DEPARTMENT OF PLANNING JEFFERSON PARISH, LOUISIANA

DESIGN REVIEW REPORT

DOCKET NO: CPZ-59-16	ADVERTISING DATES:	11/30/16 12/07/16 12/14/16
SUMMARY NO.:		
COUNCIL DISTRICT: 5: Jennifer Van Vrancken	PAB PUBLIC HEARING:	12/22/16
COUNCIL AT LARGE: A: Christopher L. Roberts B: Cynthia Lee-Sheng	COUNCIL HEARING:	
	LAST MEETING DATE FOR COUNCIL ACTION:	04/05/17

To add a second attached sign for Starbucks Coffee and a third detached sign on Lot 1-B with variances to the sign regulations of the CPZ

FIGURE 3

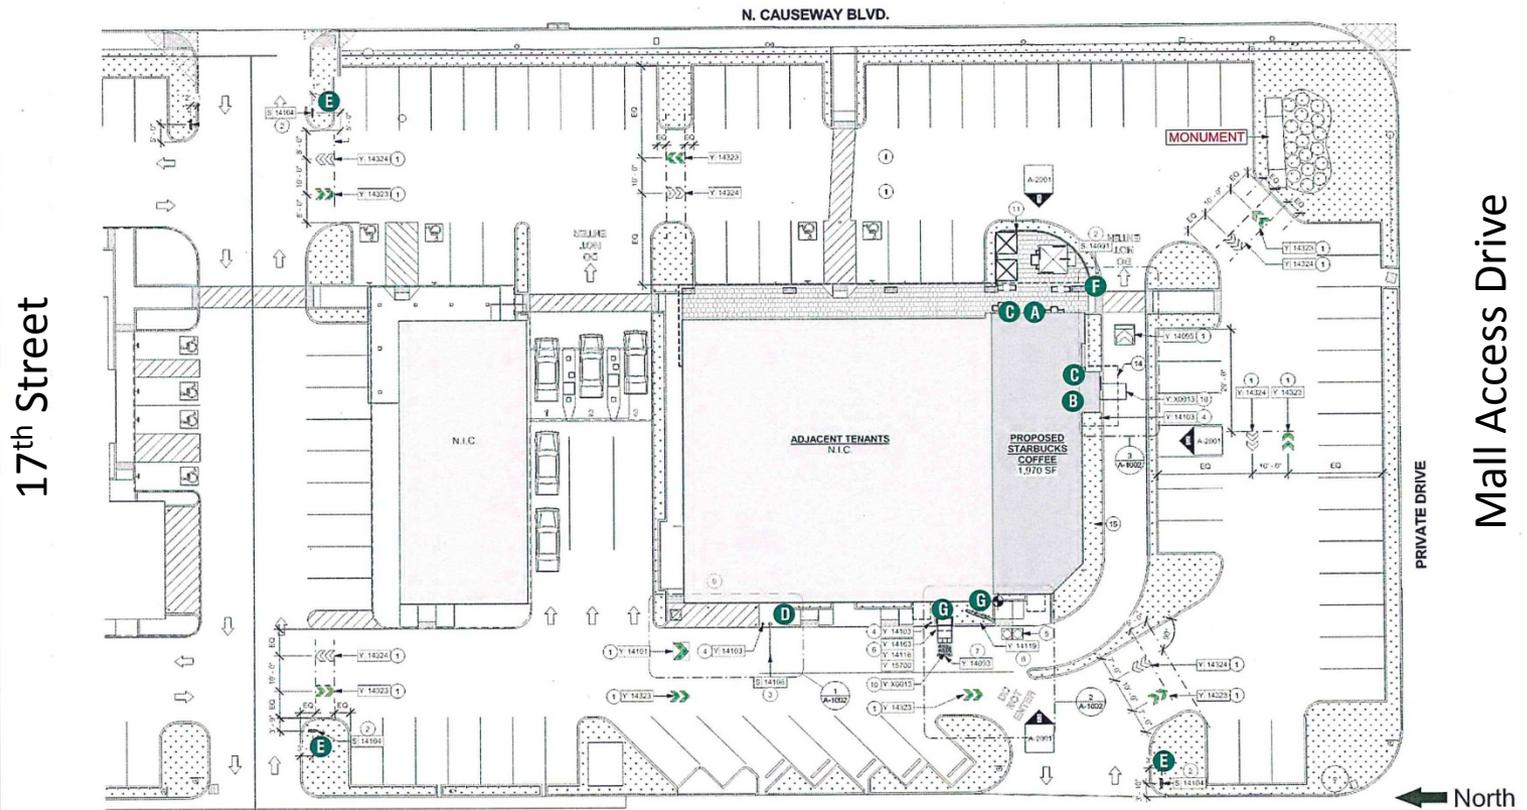
4. Sec. 40-477(b)(1) states that each use shall be allowed one attached sign to be computed at three sq. ft. per lineal foot of primary building frontage elevation on which the sign is to be located, not to exceed 300 sq. ft. Starbucks Coffee has 30 ft. of building frontage and is allowed 90 sq. ft. of sign area. The applicant proposes two attached signs for Starbucks Coffee—one at 19.62 sq. ft. on the east building elevation primary frontage and one on the south building elevation at 12.56 sq. ft.—for a total sign area of 32.18 sq. ft., which is 57.82 sq. ft. below the total square footage allowed for one attached sign. A variance for one additional attached sign is requested (Figures 3-5).

ICE - Building is OPPOSED to this Case for the following reasons: 1. Attached sign noted B exceeds the allowable number of attached signs per use. Article XXVI Section 40-477 (b) (1) 2. Detached canopy sign with order screen adds to the already exceeded allowable number of detached signs per development. Article XXVI Section 40-477(b)(3) 3. Noted sign at Southeast corner within landscaped area is existing.

FIGURE 6

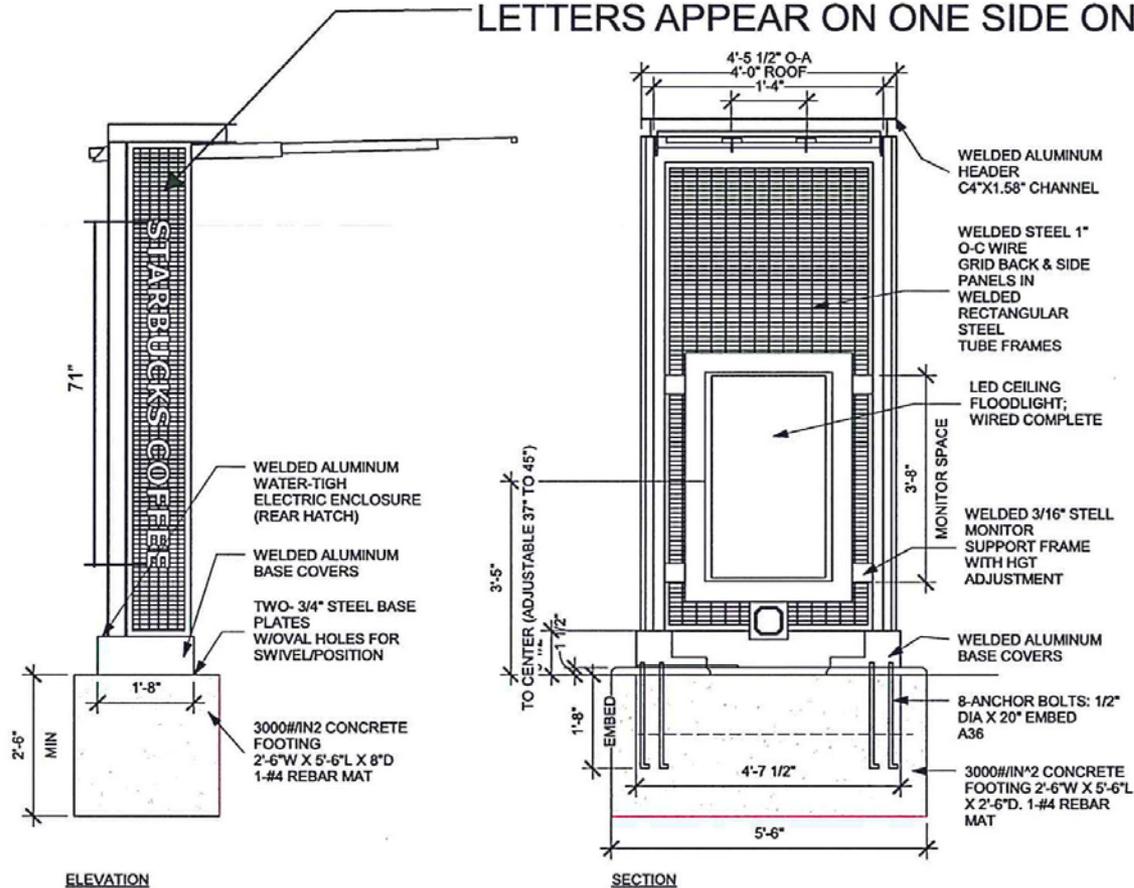
5. Sec. 40-477(b)(3) states that each development shall be allowed one on-premises detached sign whose allowable area shall not exceed one square foot per lineal foot of lot frontage or 300 square feet, whichever is less. Since Lot 1-B has 335 feet of frontage on N. Causeway, a 300 sq. ft. sign is allowed. There is an existing detached sign for Lakeside Mall and a second 60 sq. ft. detached sign on the property was approved by Ordinance No. 25255 (Docket No. CPZ-53-16) along the N. Causeway frontage to service the tenants of the new retail approved under CPZ-10-16, which includes Starbucks Coffee. The applicant proposes a 2.18 sq. ft. vertical

detached sign at a drive-thru lane. Since there are already two approved detached signs on the petitioned lot, a variance is requested for the third detached sign (Figure 6).
